UNITED STATES PATENT AND TRADEMARK OFFICE

10/551,141

Office Action Summary	Application No.	Applicant(s)	
	10/551,141	KARLSSON, DENNIS	
	Examiner	Art Unit	
	Syed A. Islam	3677

DETAILED ACTION

Figure A

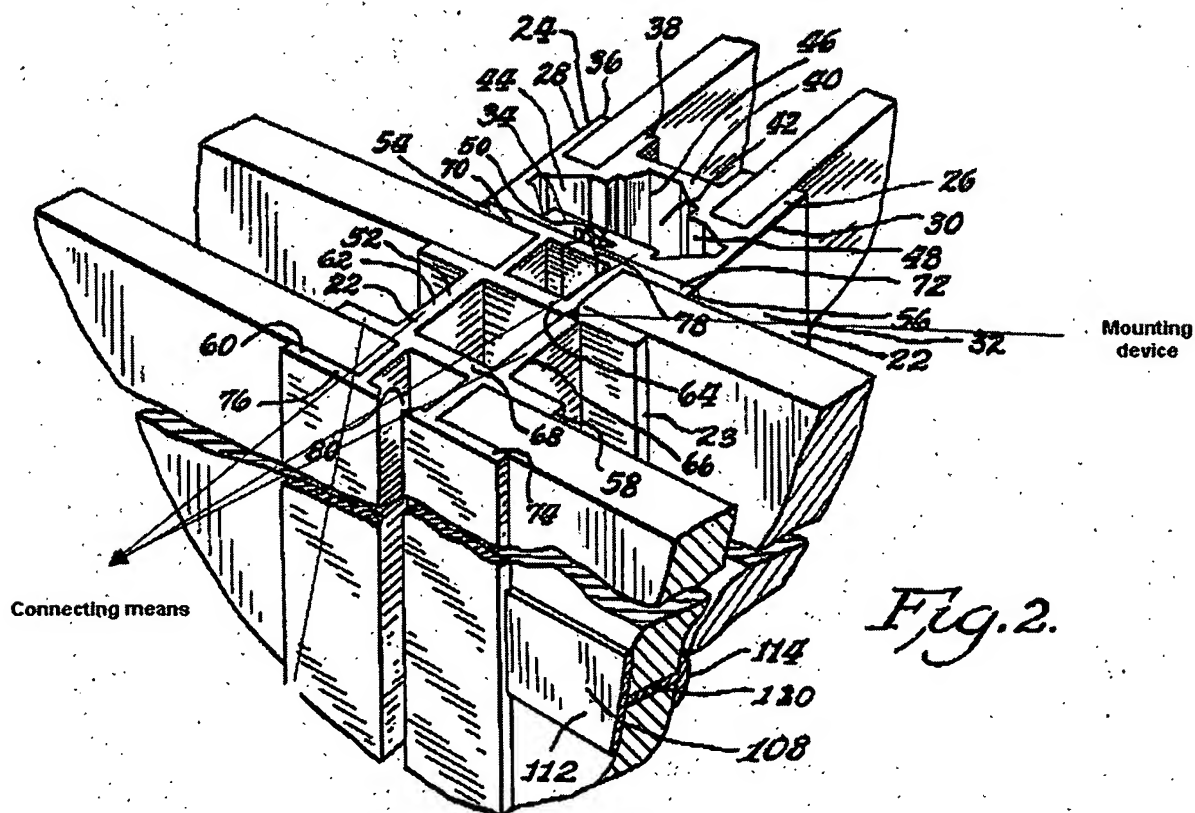
Regarding claim 27, Trusiani as modified discloses the claimed invention except for said mounting device is provided with at least two connecting means, arranged at different angles in relation to each other. However, Donovan teaches that a mounting device is provided with at least two connecting means, arranged at different angles in relation to each other. See figure A below. Therefore, it would have been obvious to one of ordinary skill in the art at the time of invention to use the teaching of Donovan in the invention of Trusiani as modified for the purpose of supporting multiple sign at one point since it is inexpensive and easy.

Regarding claim 28, Trusiani as modified discloses the claimed invention except for said mounting device is provided with at least two connecting means displaced by 90°. However, Donovan teaches that mounting device is provided with at least two connecting means displaced by 90°. See figure A above. Therefore, it would have been obvious to one of ordinary skill in the art at the time of invention to use the teaching of Donovan in the invention of Trusiani as modified so that sign will not touch when they are in use.
